PM7326 S/UNI-APEX

ATM/PACKET TRAFFIC MANAGER AND SWITCH

ERRATA

ISSUE 1: APRIL 2000

2.1 Service Arbitration Round-Robin Behavior

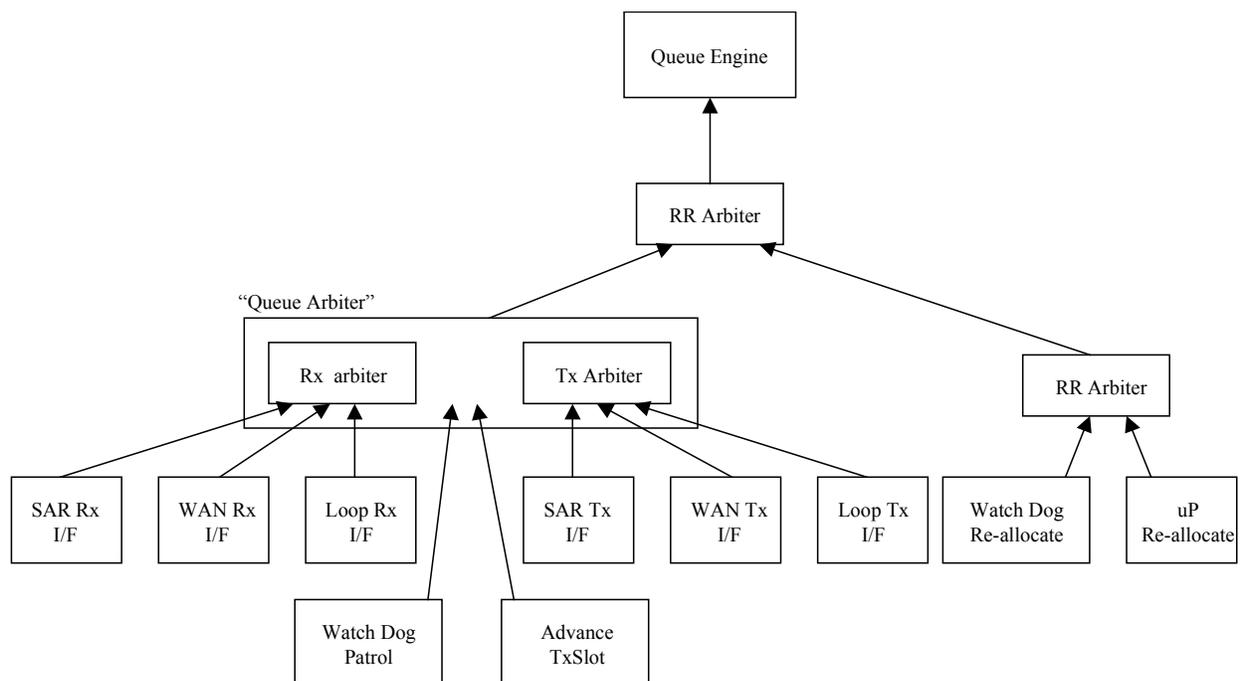
In very limited circumstances, the service arbitration process may be inconsistent with the description shown in Section 10.9.1 of the data sheet. Referring to Figure 14 in the data sheet (reproduced below), in some cases the watch dog reallocation procedure may temporarily cause the Rx or Tx arbiters to repeatedly

service the same interface (SAR, loop or WAN) until reallocation is complete. This could cause potential starvation of one of the remaining interface services.

This is caused because the Rx and Tx arbiters continue to cycle even when the watch dog arbiter has “won” the next Queue Engine opportunity. This effectively blocks the next interface selected by the Rx or Tx arbiter from being serviced for that cycle. If multiple ICIs simultaneously time out, the watch dog could cause the same interface to be repeatedly blocked, which could starve the interface.

The effect of this behavior is dependent on the activity at the interfaces. A possible worst case scenario would occur if all of the following conditions were present:

- Two out of three interfaces (WAN, Loop or SAR) have 2 or more cells in the internal FIFOs waiting to be serviced
- Frame contiguous queuing of VCs is being used
- The VC timeout watch dog is enabled (QWwdActive=1)
- The watch dog patrol is executed and discovers re-assembly time out errors in VCs that have sequential ICIs

The probability of a re-assembly time out for a sequence of VCs would be very low in normal operations. The most likely worst case scenario would be the simultaneous time out of all VCs associated with a given port due to a catastrophic fault on that port. If the VCs on any given port were mapped to non-sequential ICIs, the Rx and Tx interfaces would have an opportunity to successfully service requests between VC reallocations.

Typically there will be a device between the S/UNI Apex and the link layer that can perform an address resolution function (the S/UNI Atlas for example). This device could be also be used to map each VC on a port to non-contiguous ICIs.

One possible strategy would be to map VCs on even-numbered ports to even-numbered ICIs and VCs on odd-numbered ports to odd-numbered ICIs. This “striping” would ensure that the VCs associated with any port fault would not occupy contiguous ICIs and would therefore avoid the service arbitration behavior described above.
